### AMENDMENTS TO THE DRAWINGS

Appl. No. 10/046,066  
Amdt. Dated Oct. 13, 2005  
Reply to Office Action of Jan. 27, 2005  
Annotated Sheet Showing Changes

FIG. 3

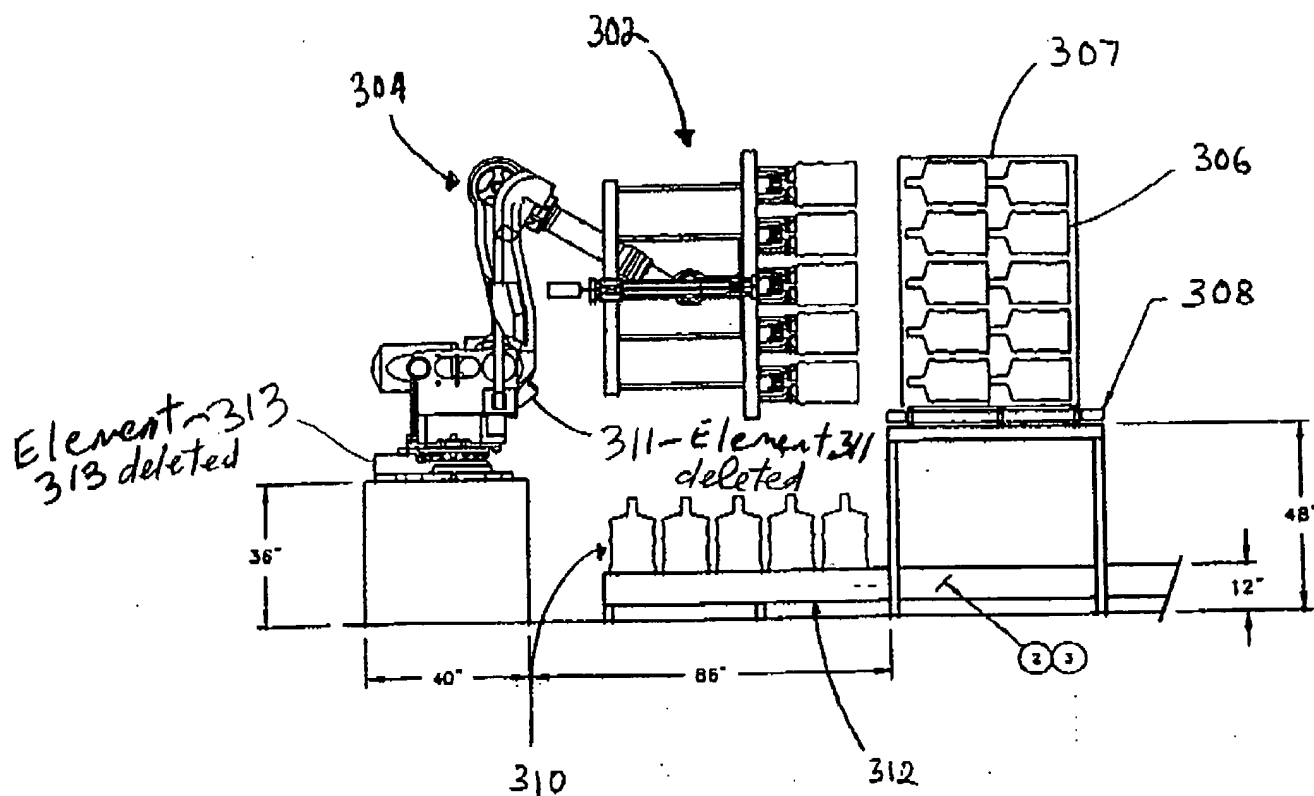
The attached sheets of drawings include changes to Fig. 3. These sheets, which includes Fig. 3, replaces the original sheet including Fig. 3. In amended Figure 3, element numeral 313 and 311 have been deleted. 313 and 311 were previously added to figure 3 to reflect "motorized base" and "interface" in previous presented claims. These claims, however, are now canceled. Further more, "motorized base" was actually referred to drive 222 and 226, and not as identified by 313. And, "interface" is adequately noted in figure 2A, and incorrectly identified by 311.

In amended Figure 3, element numeral 313 and 311 have been deleted. 313 and 311 were previously added to figure 3 to reflect "motorized base" and "interface" in previously presented claims. These claims, however, are now canceled. Furthermore, "motorized base" was already identified by drive 222 and 226. And, "interface" was already identified in figure 2A.
